Access Compliance Report

Public Rights-of-Way

Intersection ID: 10041619	Main Street: WHITEHALL COMMONS CENTER DR	Cross Street: N/A	Location: SE
ADA ID: CD67FB97DE27	Ramp Type: PerpDiag	Initial Pass/Fail: Fail	Overall Compliance: No
Codes/Mitigation Info/Possible Solution		Field Measurements/Component Compliance	
Severity Score: 10

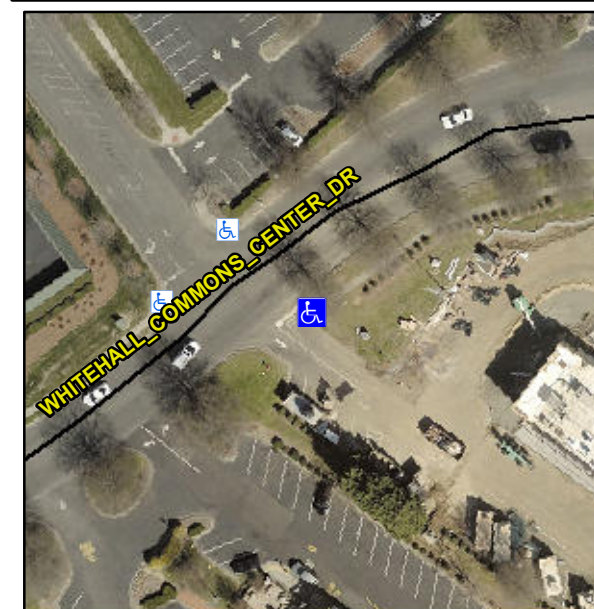
Not Found, R304.5.1, R304.5.3

Compliance	Description	Data	Compliance	Description	Data
N/A	Ramp Length (in)	58.0	Yes	Ramp Slope (%)	5.5
No	Ramp Width (in)	45.0	No	Ramp XSlope (%)	3.3
N/A	Flare Type LT	N/A	N/A	Flare Type RT	N/A
N/A	Flare Slope LT (%)	N/A	N/A	Flare Slope RT (%)	N/A
N/A	Flare Traversable LT?	N/A	N/A	Flare Traversable RT?	N/A
N/A	Landing Length (in)	N/A	N/A	DWS Provided?	N/A
N/A	Landing Width (in)	N/A	N/A	DWS Contrast?	N/A
N/A	Landing Slope (%)	N/A	N/A	DWS Length (in)	N/A
N/A	Landing X Slope (%)	N/A	N/A	DWS Full Width?	N/A
N/A	Landing Curb? (Y/N)	N/A	N/A	DWS Offset (in)	N/A
N/A	Shared Landing?	N/A			
N/A	Gutter Ponding?	N/A	N/A	Gutter Slope (%)	N/A
N/A	Gutter Lip Ht (in)	N/A	N/A	Gutter X Slope (%)	N/A
N/A	Painted X Walk1?	No	N/A	Painted X Walk2?	No
	X Walk 1 Direction	To N		X Walk 2 Direction	To W
N/A	X Walk 1 Width (in)	N/A	N/A	X Walk 2 Width (in)	N/A
	X Walk 1 Slope (%)	2.1		X Walk 2 Slope (%)	4.1
	X Walk 1 X Slope (%)	2.5		X Walk 2 X Slope (%)	3.0

Remove & Replace Curb Ramp With Two New Directional Ramps or Equivalent.
